RENESAS TECHNICAL UPDATE

Product Category	MPU & MCU	Document No.	TN-16C-A233A/E	Rev.	1.00
Title	Errata to R32C/153 Group User's Manual: Hardware		Information Category	Technical Notification	
Applicable Product	R32C/153 Group	Lot No.	Reference Document	R32C/153 Group User's Manual: Hardware Rev. 1.10 (REJ09B0505-0110)

This document describes corrections to the R32C/153 Group User's Manual: Hardware, Rev. 1.10. The corrections are indicated in red in the list below.

Figure 7.1 Clock Generation Circuitry

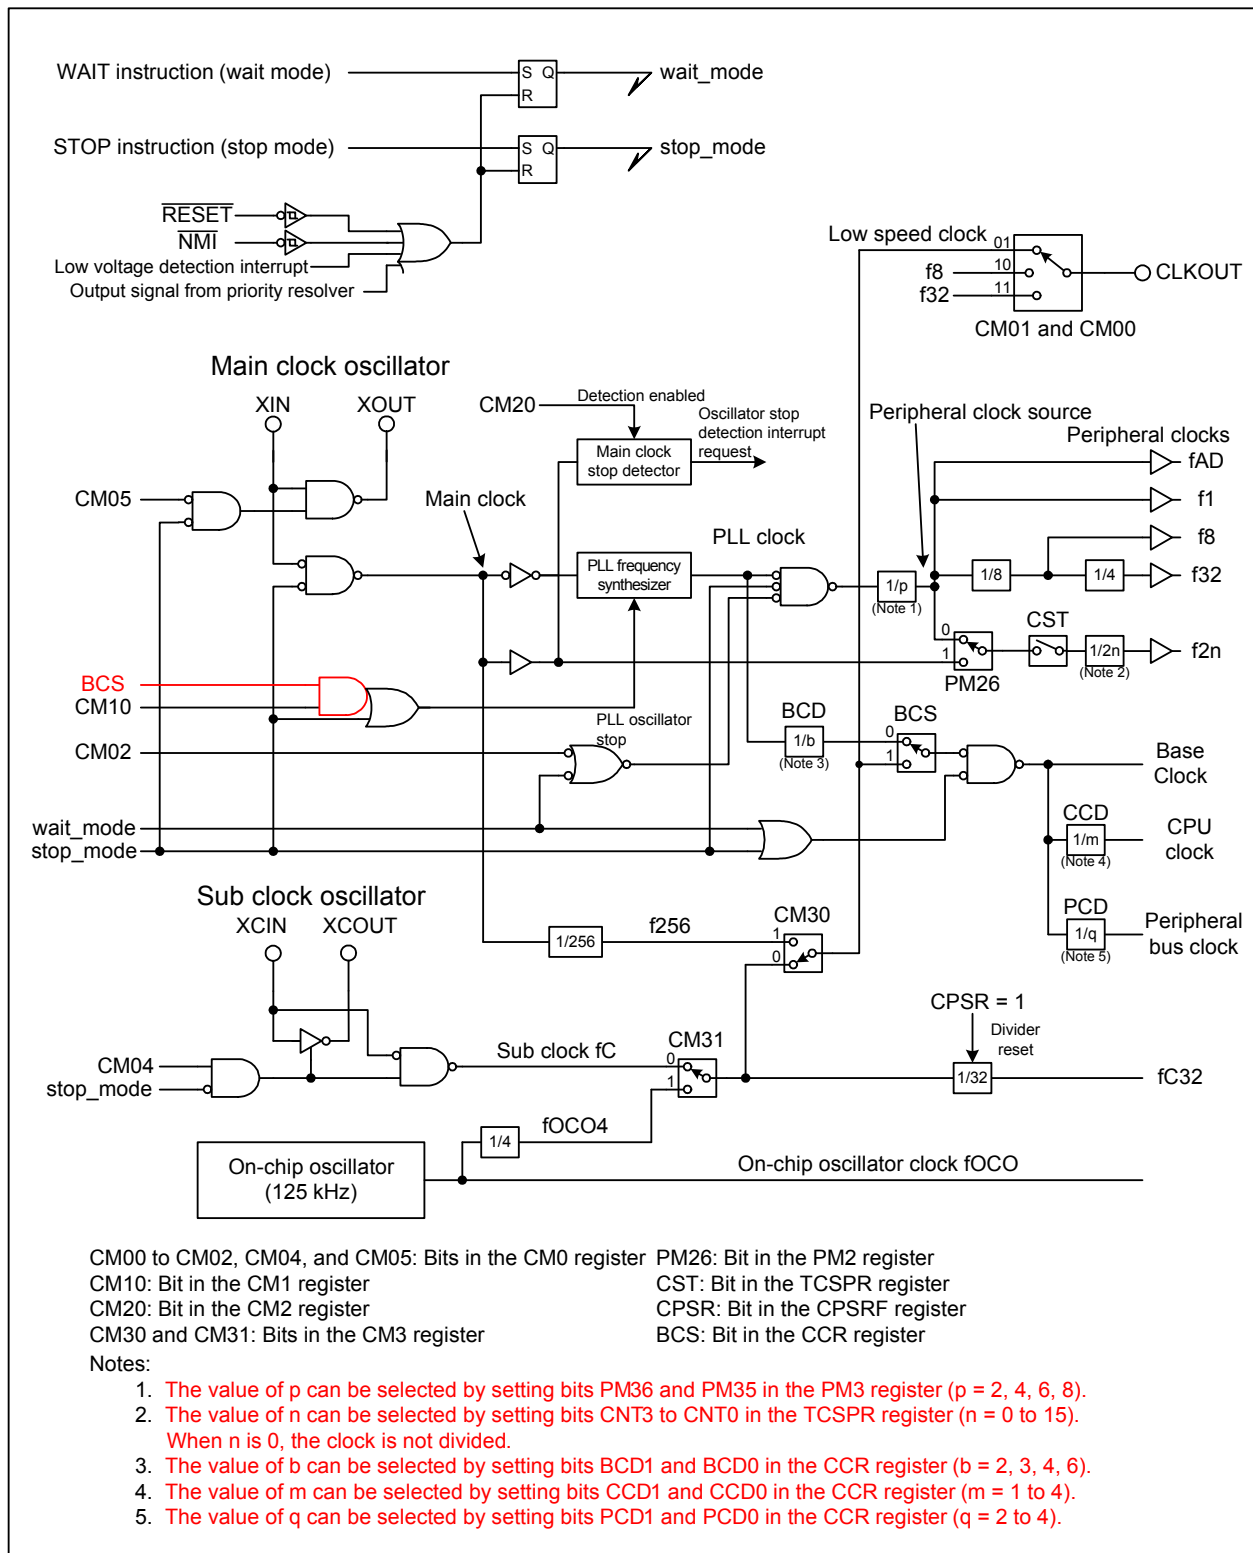
•Page 119 of 656, Figure 7.1 is corrected as follows:

Figure 20.1 CRC Calculator Block Diagram

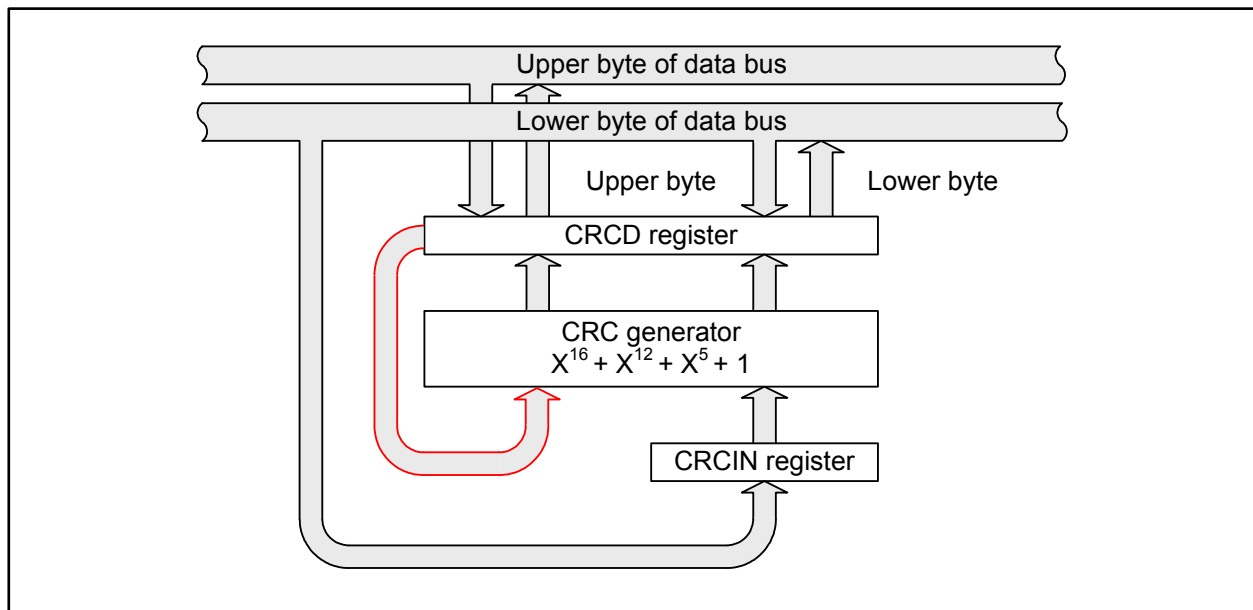
•Page 341 of 656, Figure 20.1 is corrected as follows:

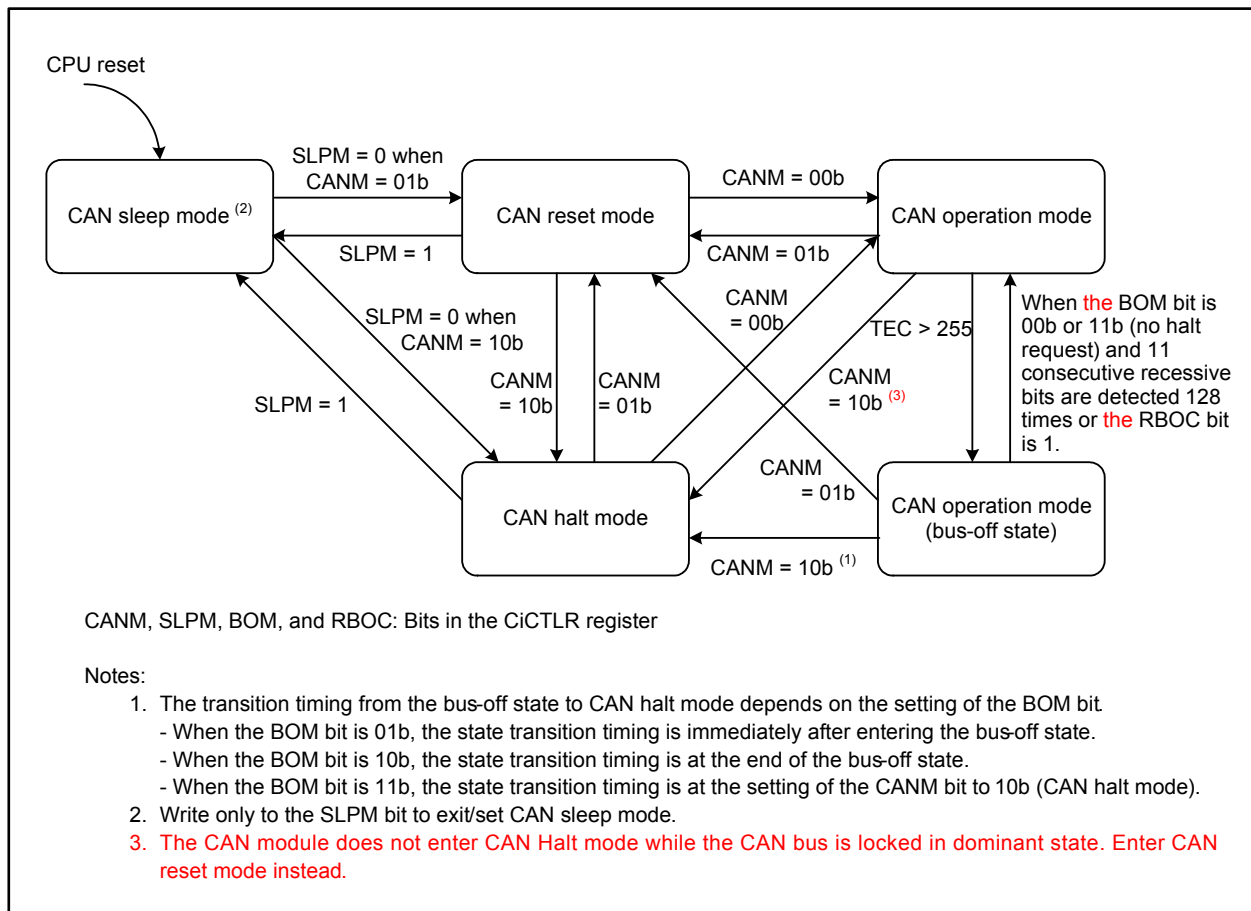
•Page 507 of 656, Note 3 is added to Figure 25.34 as follows (refer to TN-16C-A229A/E):

Figure 26.1 Typical I/O Pin Block Diagram (i = 0 to 15; j = 0 to 7)

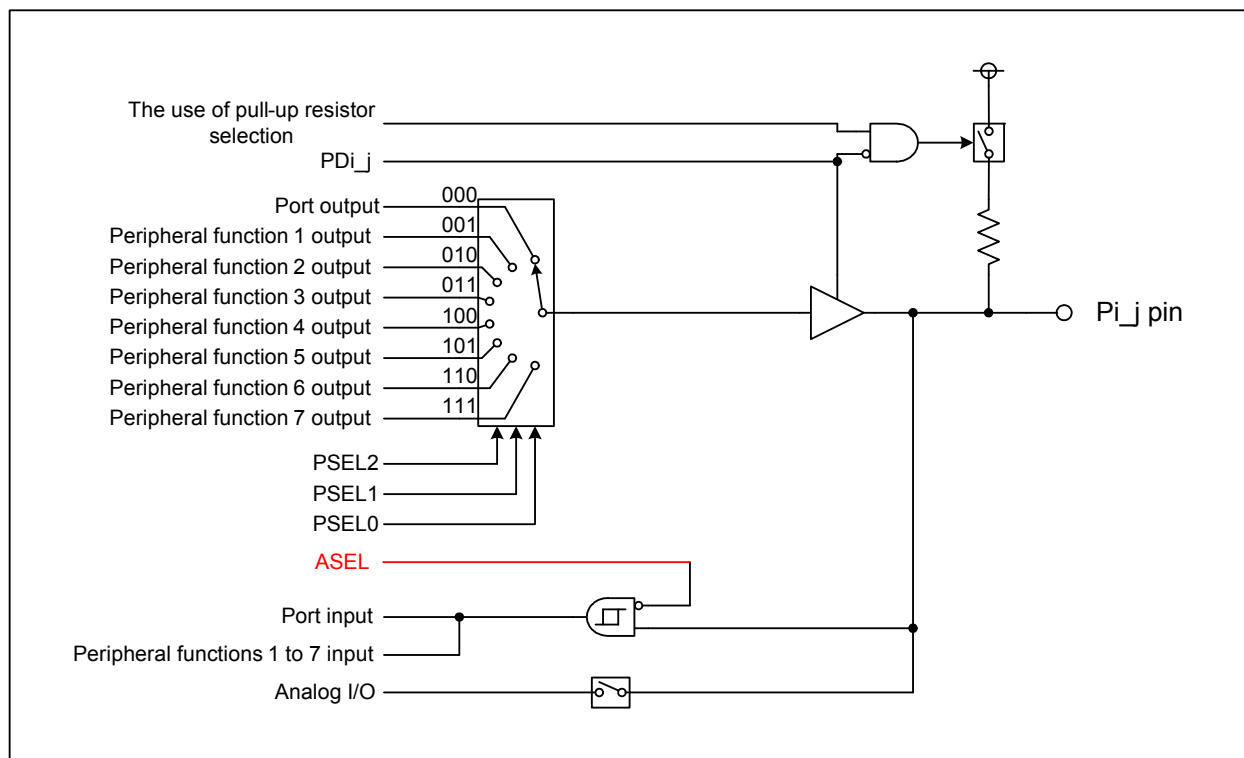
- Page 525 of 656, Figure 256.1 is corrected as follows (refer to TN-16C-A200A/E):
